**BARRACKS COMPLEX, PHASE 1  
FORT MYER, VIRGINIA**

AMENDMENT NO. 0004 TO RFP W912DR-05-R-0052  
EFFECTIVE JUN 03, 2005

SK 1

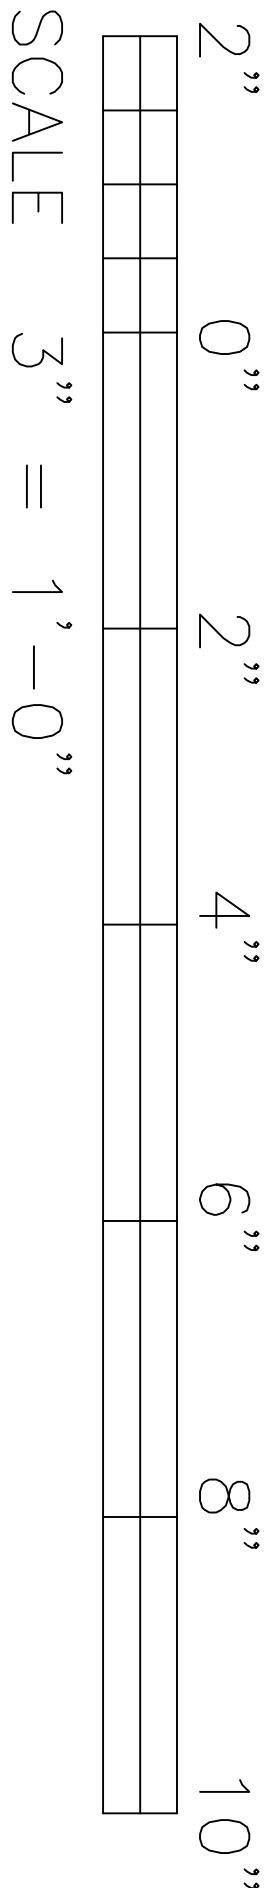
8) Sheets AE506A and AE506B: Add to both sheets the attached Sketch SK1, dated May 31, 2005.

1. DETAIL SHOWING RELATIONSHIP OF METAL NOSING AND TILE AT STAIR TREAD. ASSURE NOSING DOES NOT PRESENT TRIP HAZARD PER CODE (TYP.)
2. PROVIDE SEALANT ALONG PERIMETER OF TILE FINISH (TYP.)
